8.5x11	NO. 1800.2	drawn: Name	PROJECT: SOFTBALL DUGOUTS HOLY FAMILY H.S.	CONTRACTOR: Company
		ch'kd: name	PROJECT LOCATION: 5195 W. 160th AVE BROOMFIELD, CO 80023	RFI REQUESTER: Name
		CONSTR. REQUEST FOR INFORMATION		RFI DATE: Date
		RFI no. 4	DESCRIPTION OF THE QUESTION OR CLARIFICATION.	DESIGN FIRM: Company
				RFI RESPONDER: Name
				DATE RESPONDED: Date

1 Window Sill Detail
SCALE: NTS

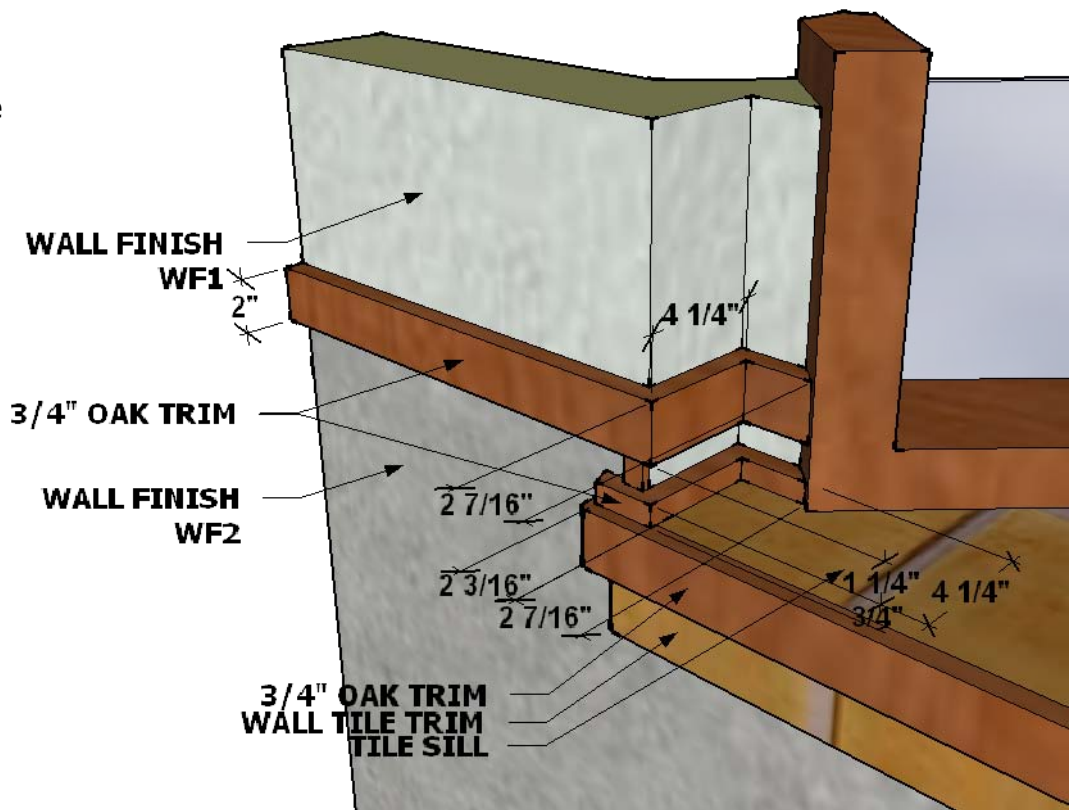
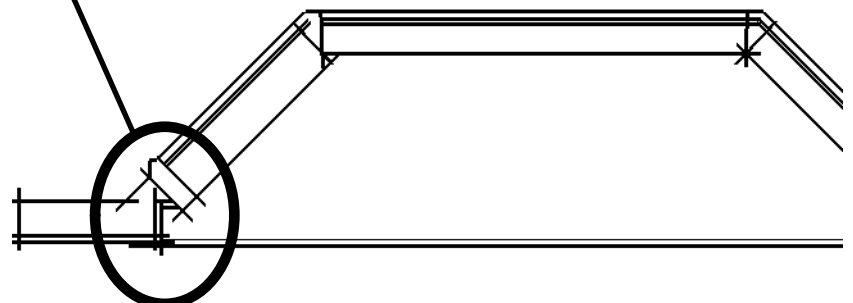
1. Verify that small piece of oak trim below chair rail is correct.
2. Verify that single course of tile is correct below wood trim?

1 Metal Bracket Detail
SCALE: NTS

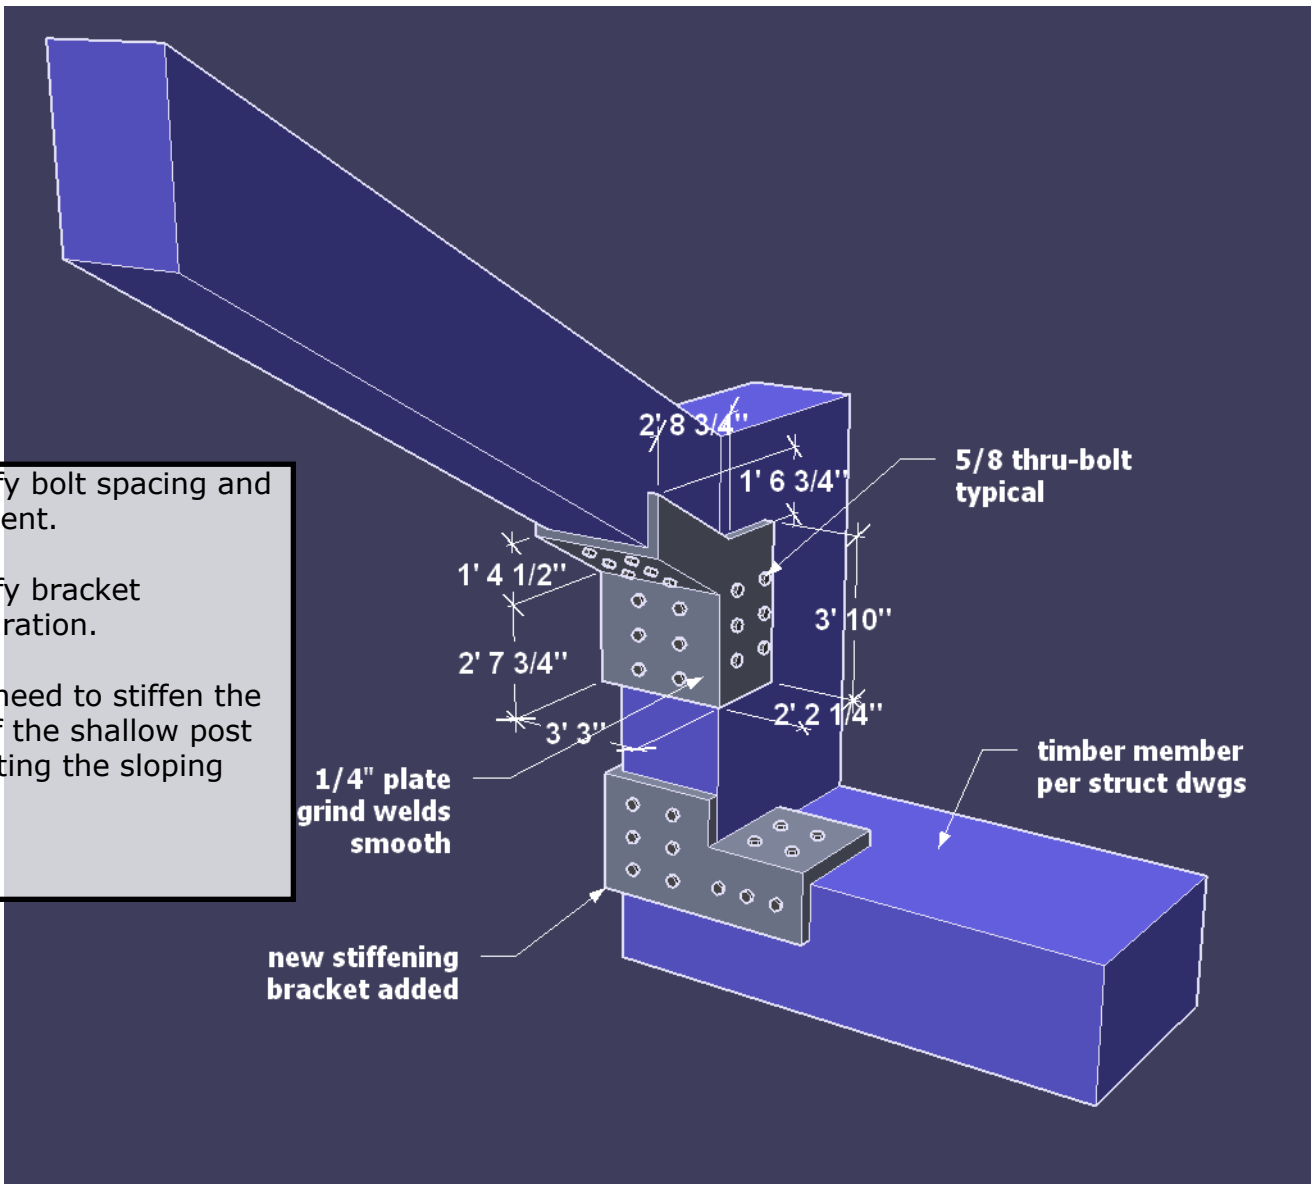
1. Verify bolt spacing and placement.
2. Verify bracket configuration.
3. We need to stiffen the base of the shallow post supporting the sloping rafter.
